The University of Sydney Health Precinct Stage 1 Project

BCA 2016 – SD Stage Final Assessment under BCA2016

Report Ref: 17-208224_PChun_UoS Health Precinct_Concept Dev_Final_20180119

DESCRIPTION
 AREA PLAN - LEVEL 3

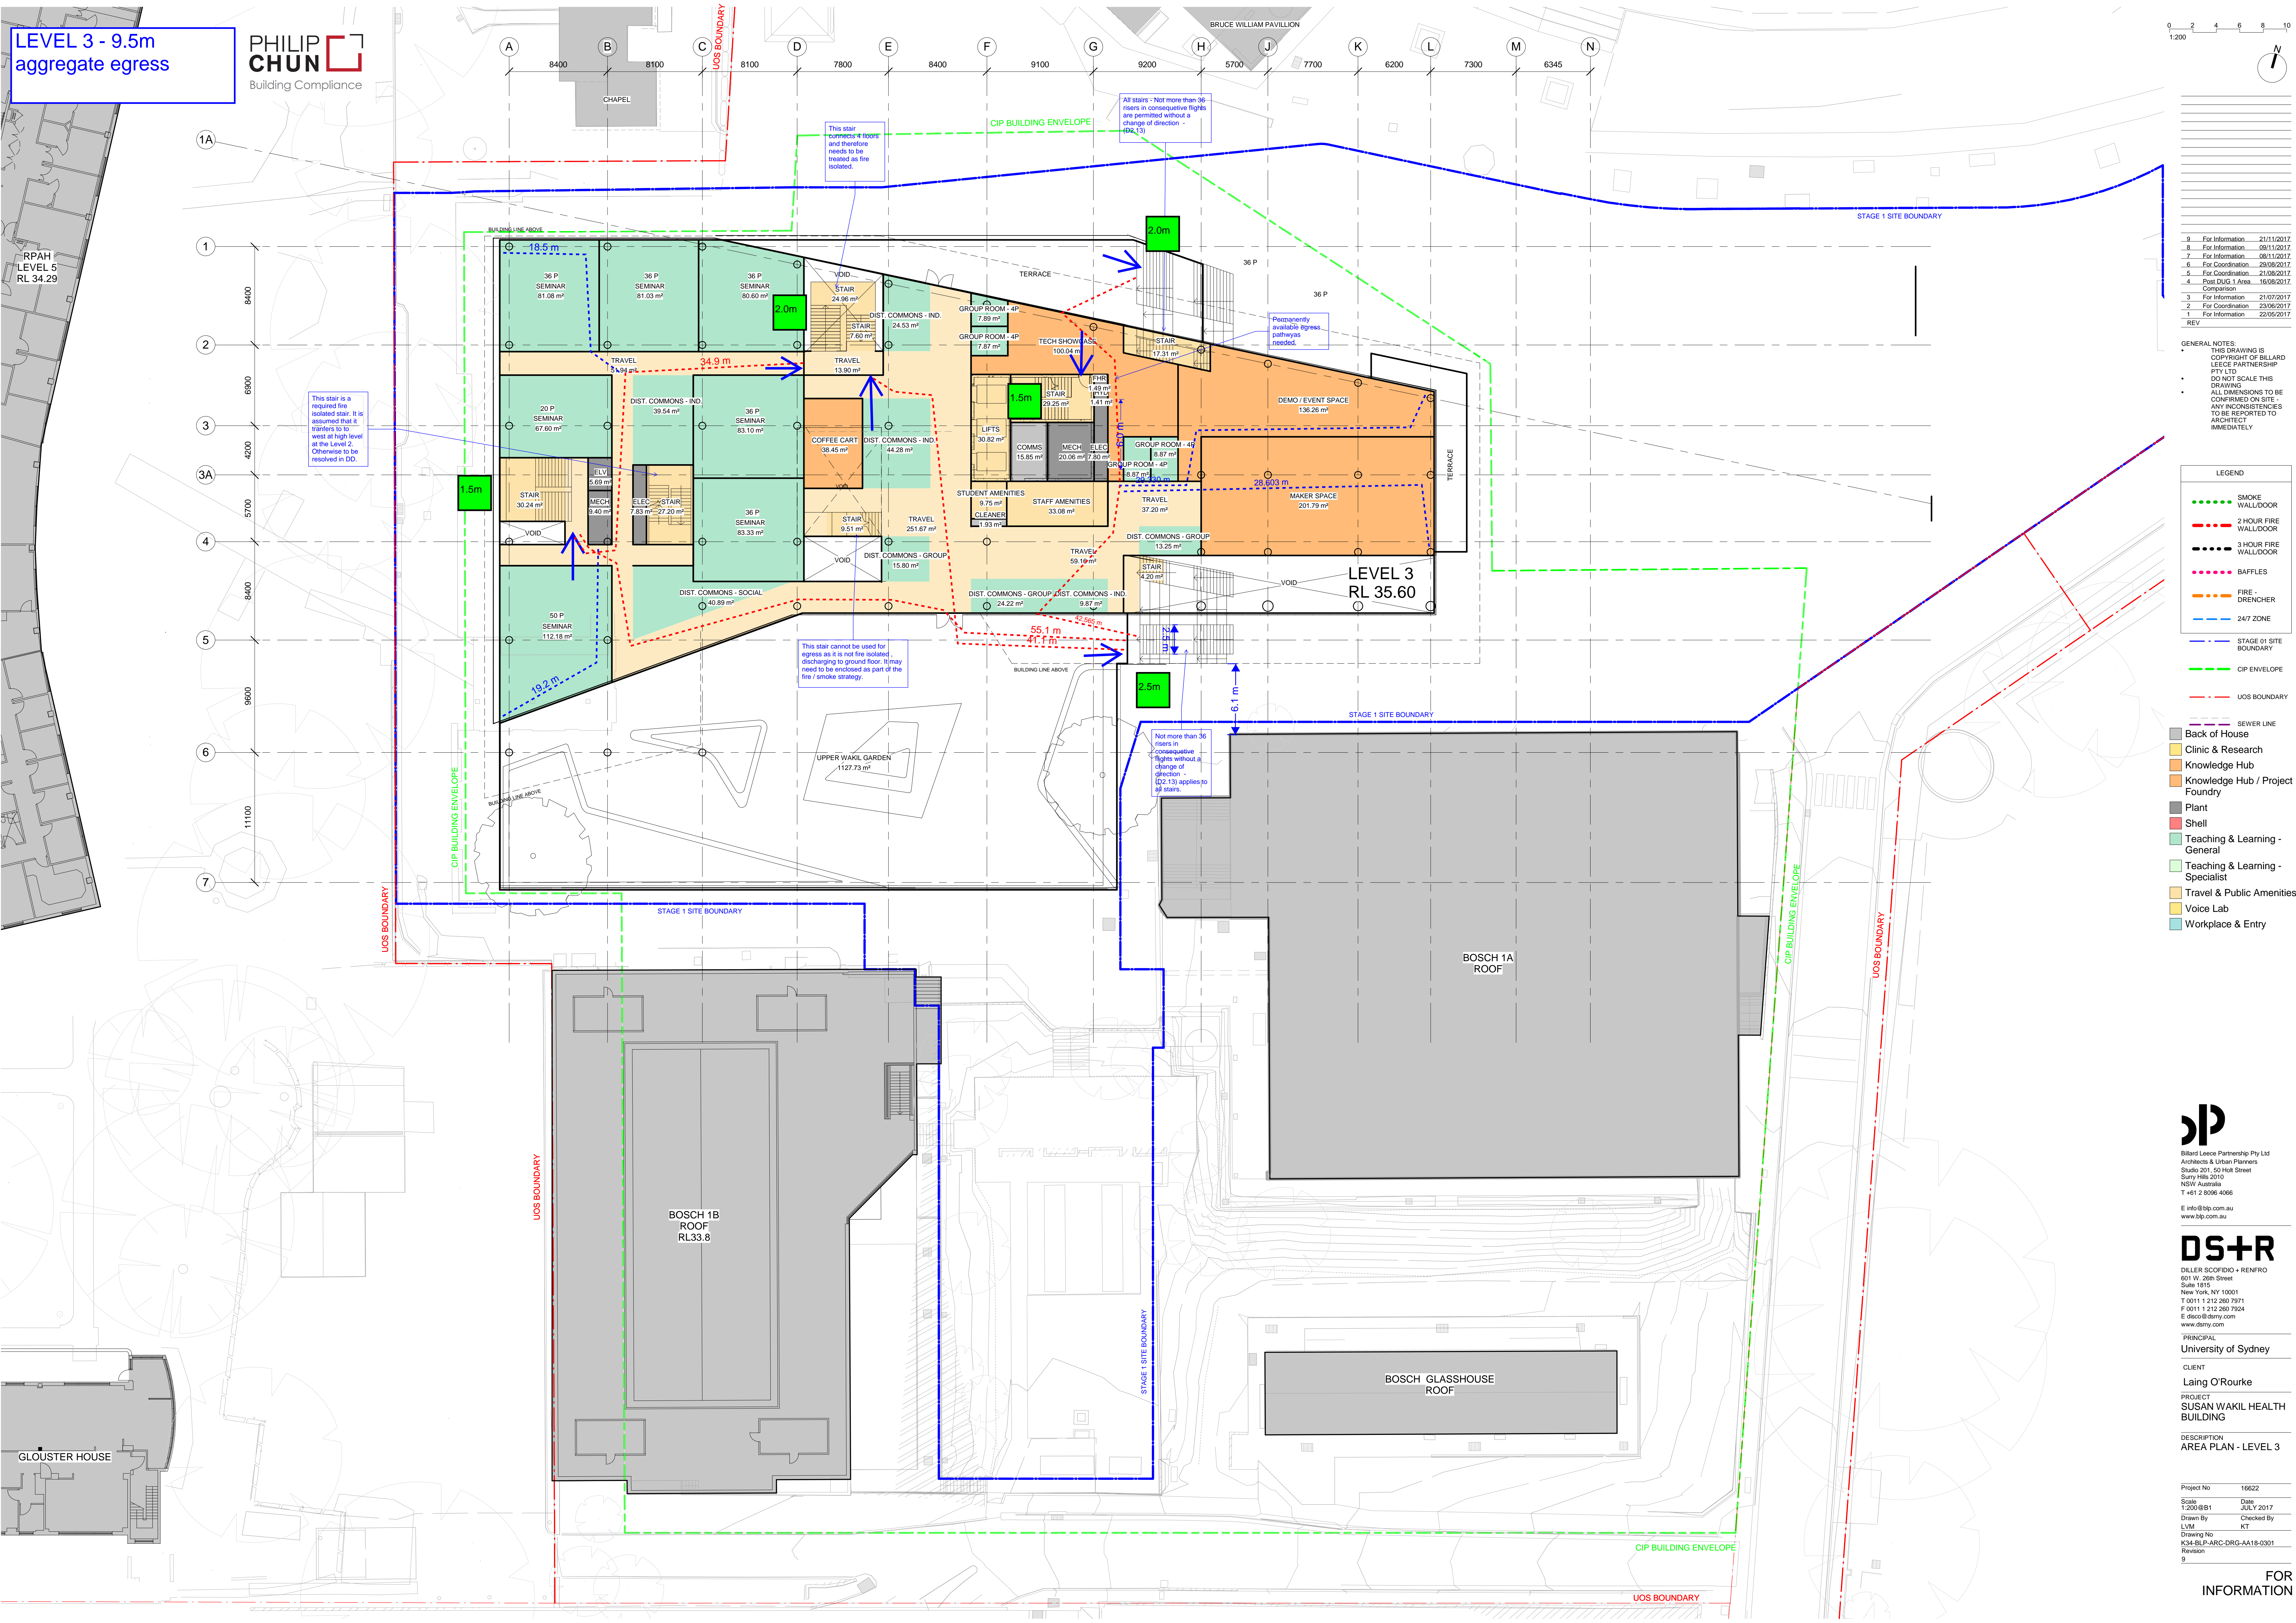
This stair is a required fire isolated stair. It is assumed that it transfers to level at high level at the Level 2. Otherwise to be resolved in DD.

All stairs - Not more than 36 risers in consecutive flights are permitted without a change of direction - (Q2.13)

This stair cannot be used for egress as it is not fire isolated, discharging to ground floor. It may need to be enclosed as part of the fire / smoke strategy.

Not more than 36 risers in consecutive flights without a change of direction - (Q2.13) applies to all stairs.

PRINCIPAL
University of Sydney
CLIENT
Laing O'Rourke
PROJECT
SUSAN WAKIL HEALTH BUILDING
DESCRIPTION
AREA PLAN - LEVEL 4

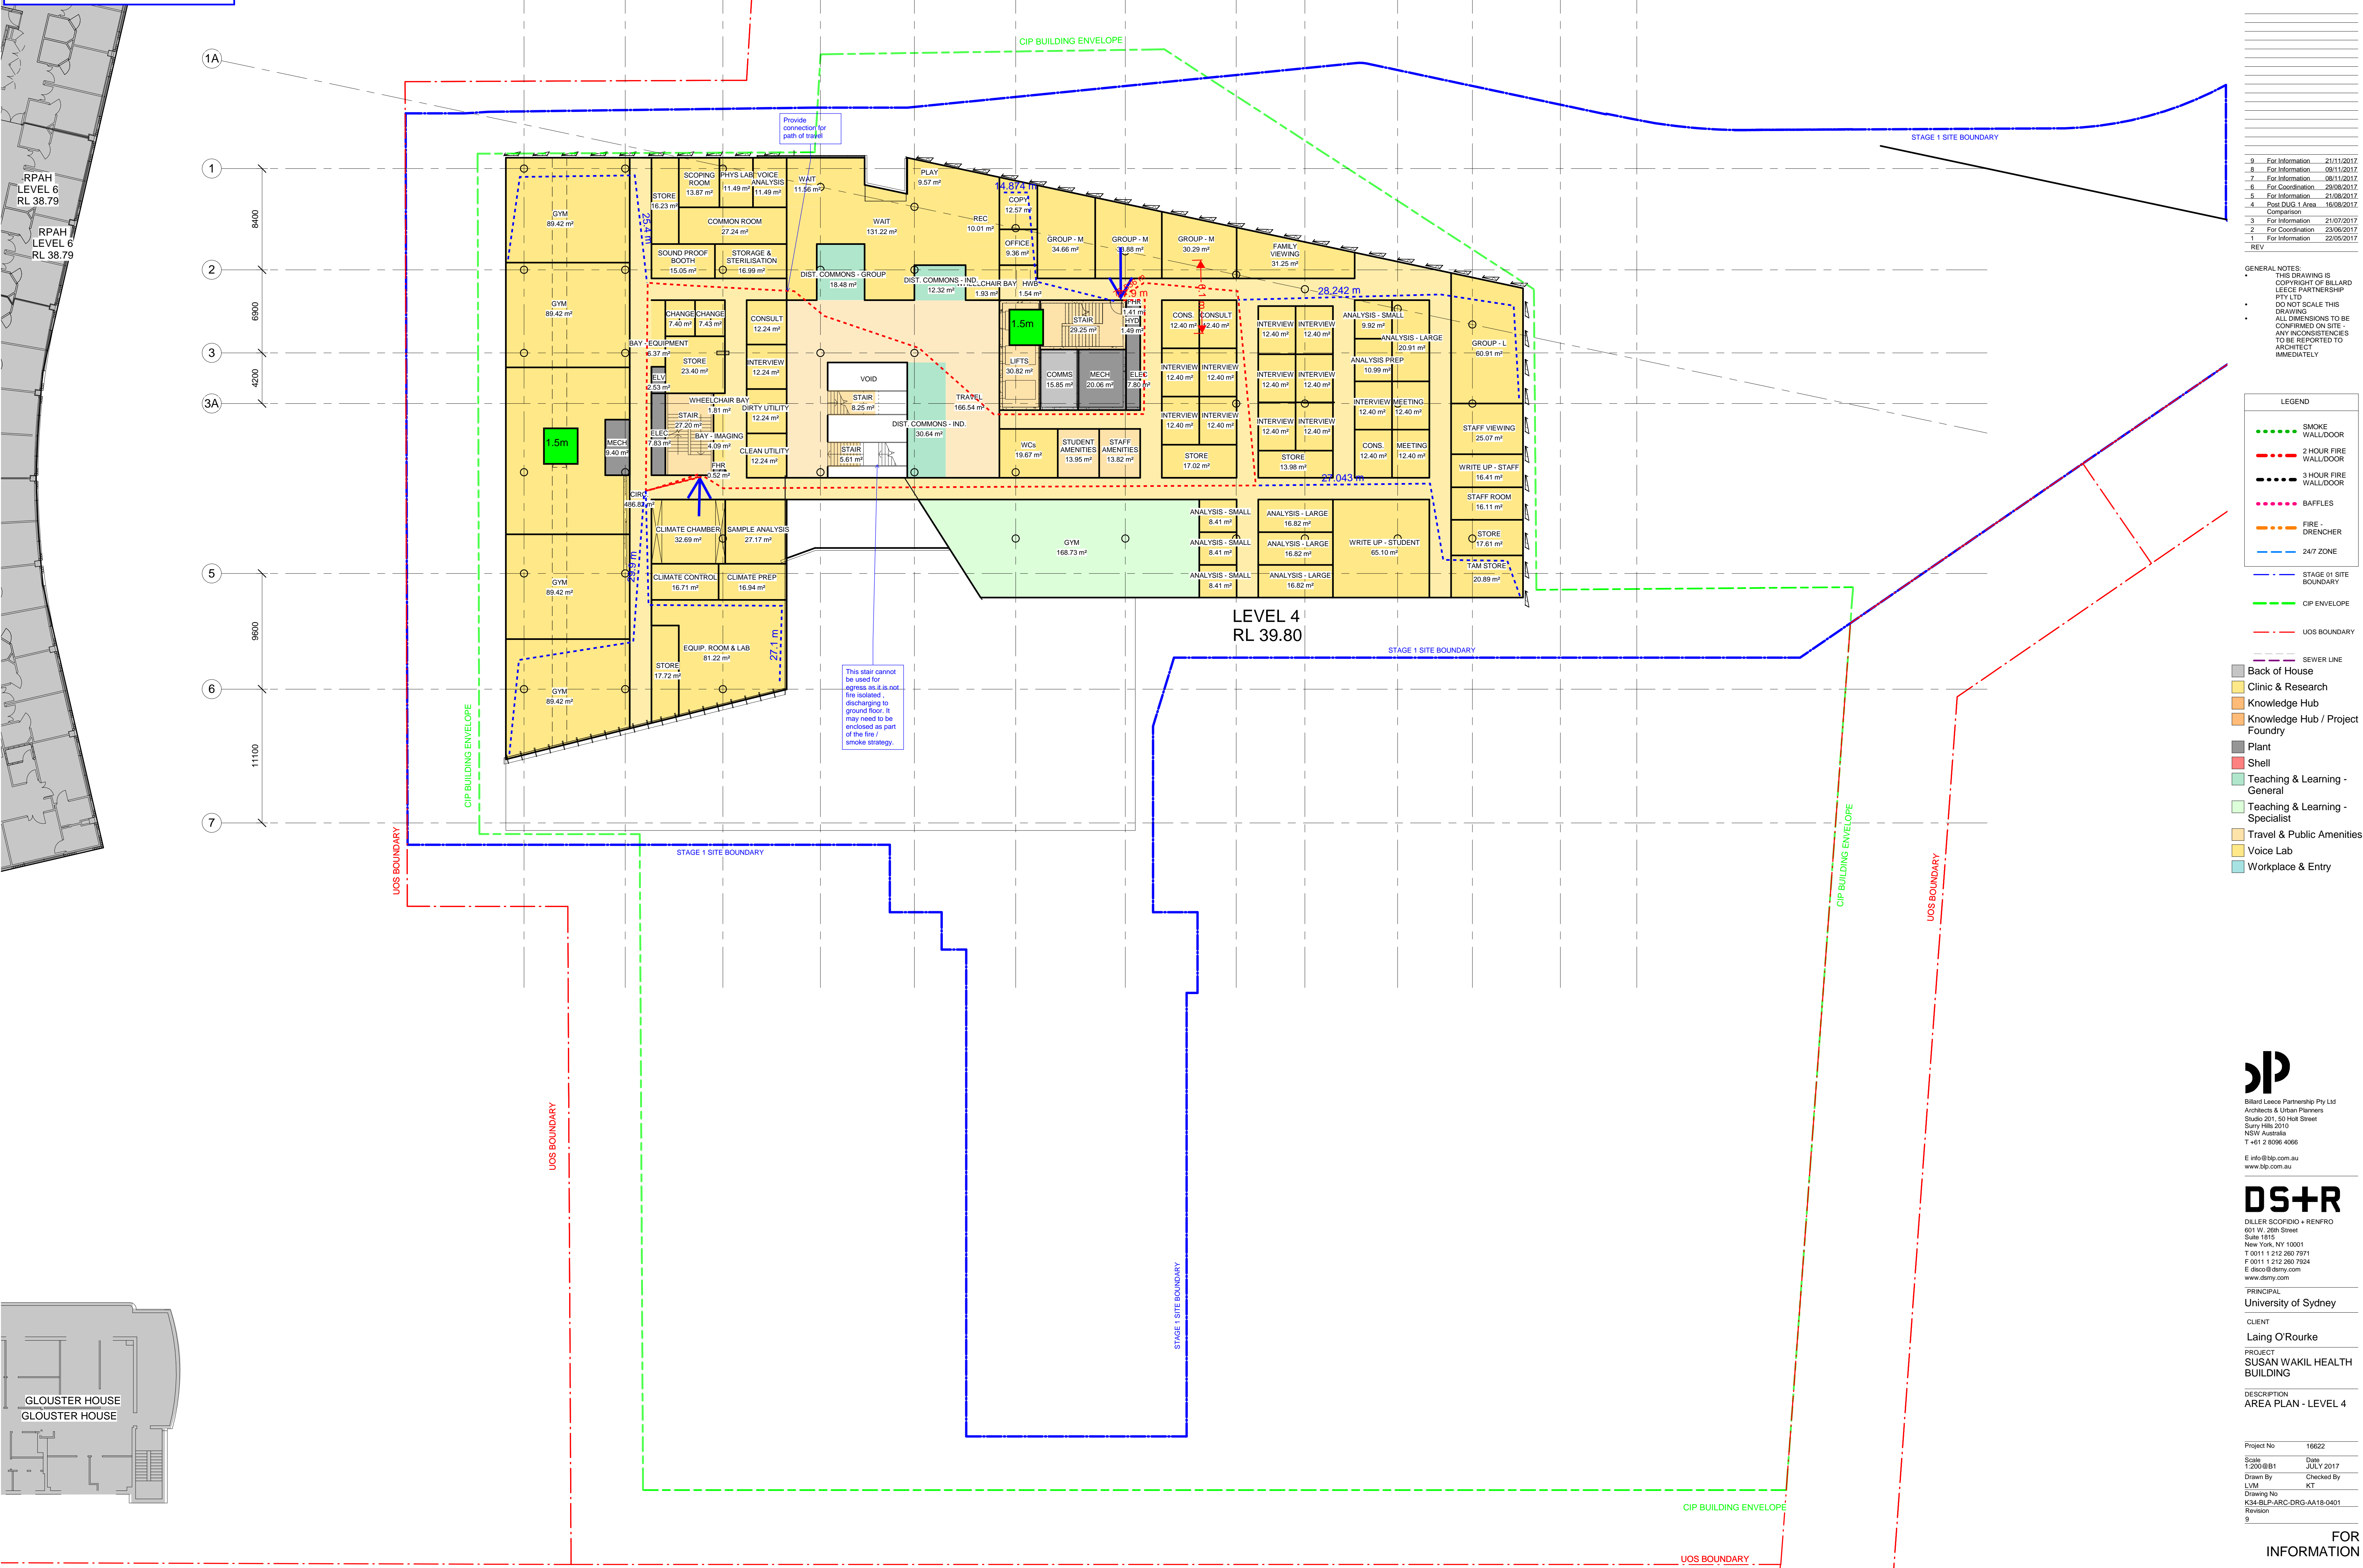
LEVEL 4 -
3m aggregate egress

DESCRIPTION
AREA PLAN - LEVEL 8

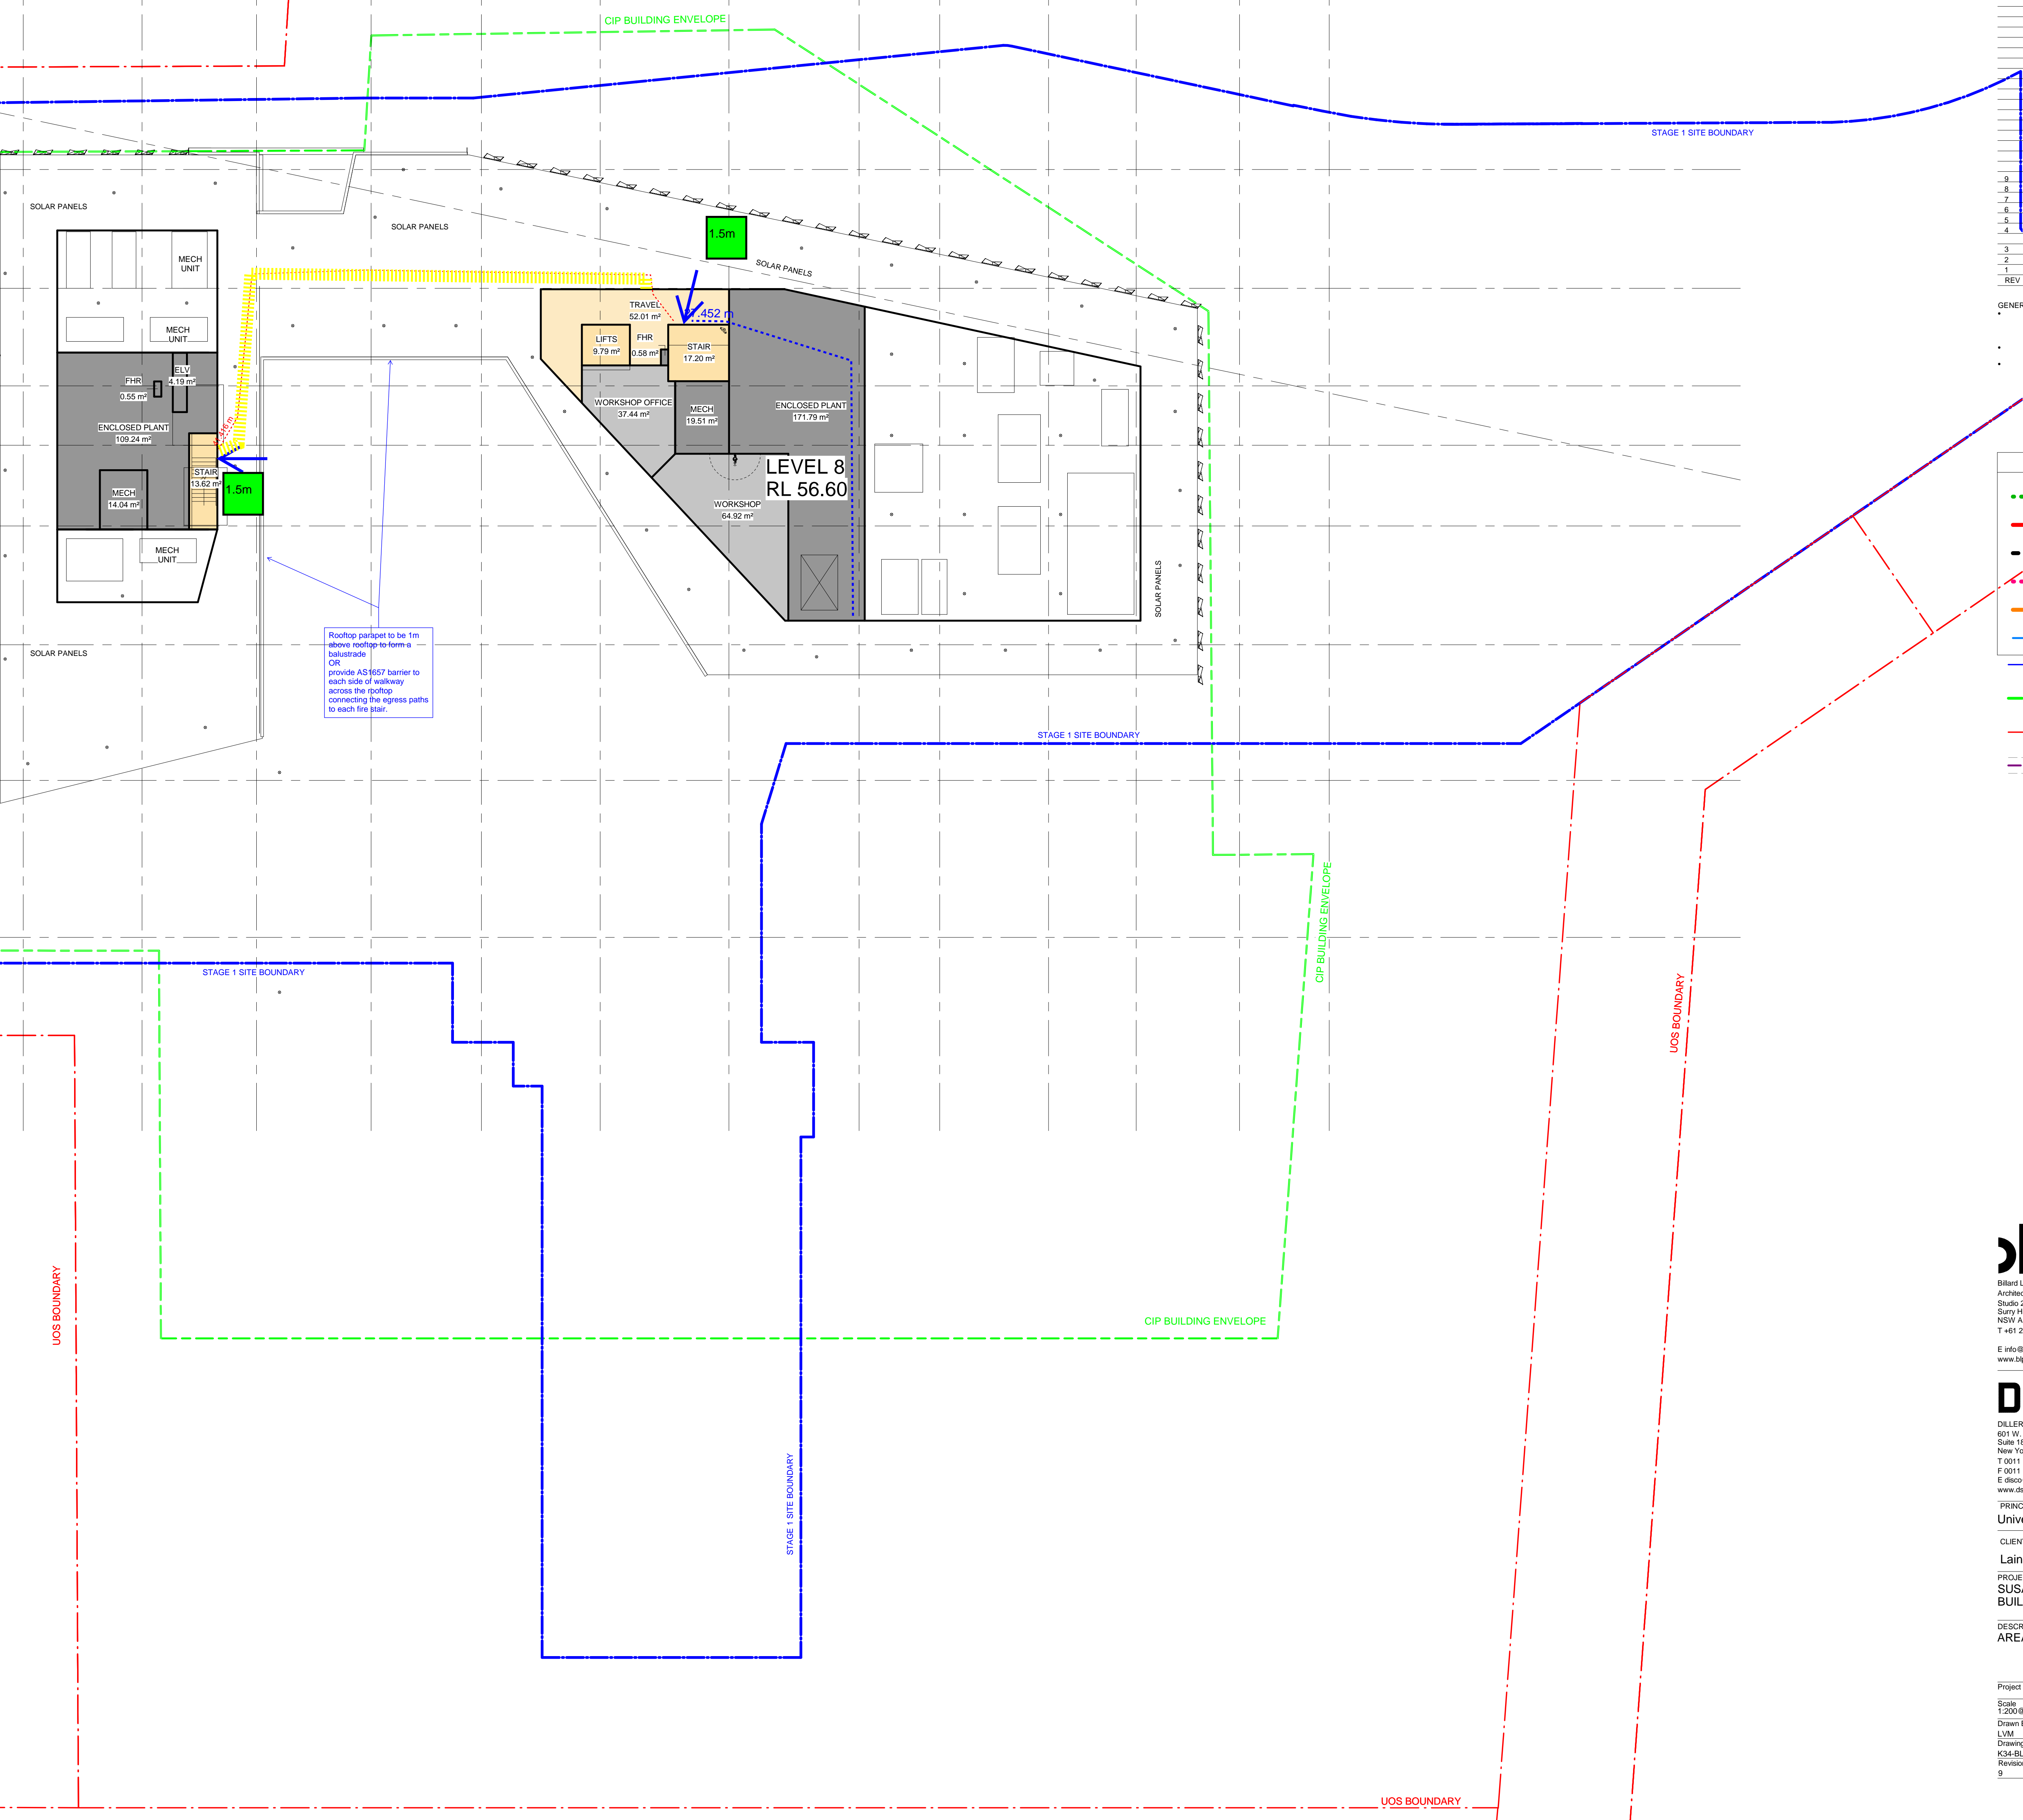
**LEVEL 8 -
3m aggregate egress**

Rooftop parapet to be 1m above rooftop to form a balustrade OR provide AS1657 barrier to each side of walkway across the rooftop connecting the egress paths to each fire stair.
